NATIONAL CONSTRUCTION CODE REPORT

RESIDENTIAL DEVELOPMENT

12-14 GLADYS AVENUE FRENCHS FOREST

24 SEPTEMBER 2024

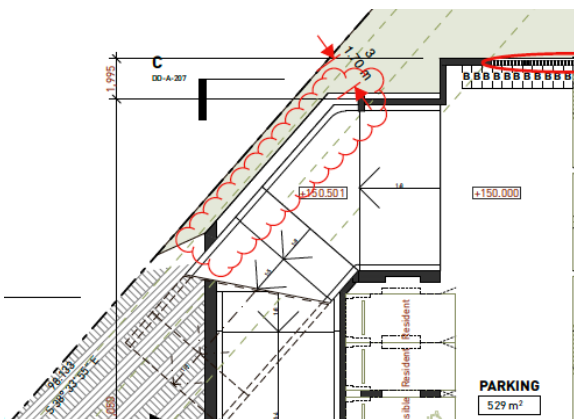
Storage areas within Basement level 1 and 2 are to have reduced FRL's to achieve 120 mins in lieu of 240 mins respectively, subject to a performance solution to address the relevant Performance Requirements of the BCA.

The proposed development is capable of achieving the required FRL's, and is to be confirmed by the structural engineer at the Construction Certificate phase.

SEPARATION OF EXTERNAL WALLS AND ASSOCIATED OPENINGS IN DIFFERENT FIRE COMPARTMENTS

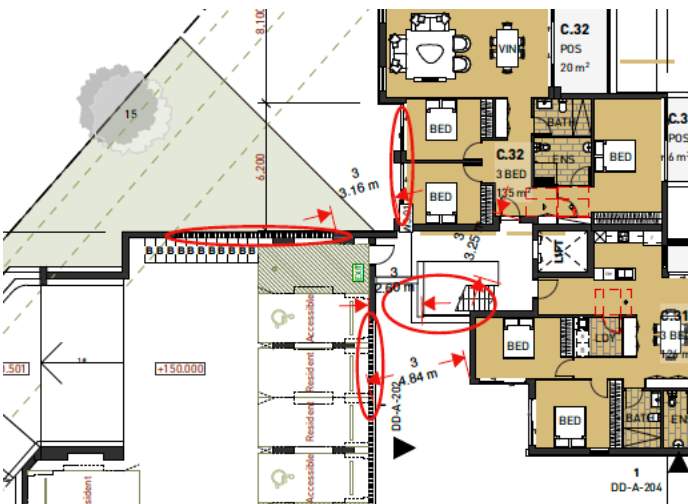
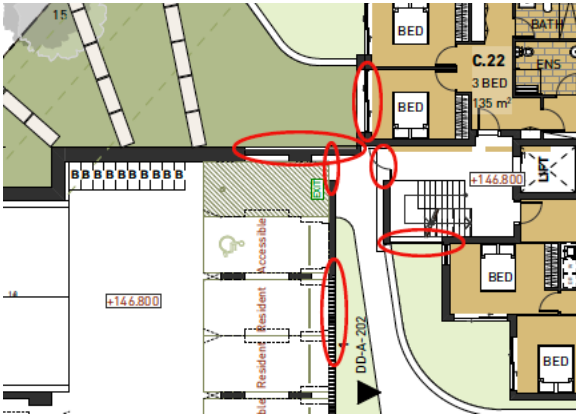
The openings between external openings between the Class 2 and Class 7a parts are within 6m which are required to be protected, as per C4D4 and C4D5. The current design does not comply and will be addressed via a performance solution which is to be prepared and addressed at the Construction Certificate stage.
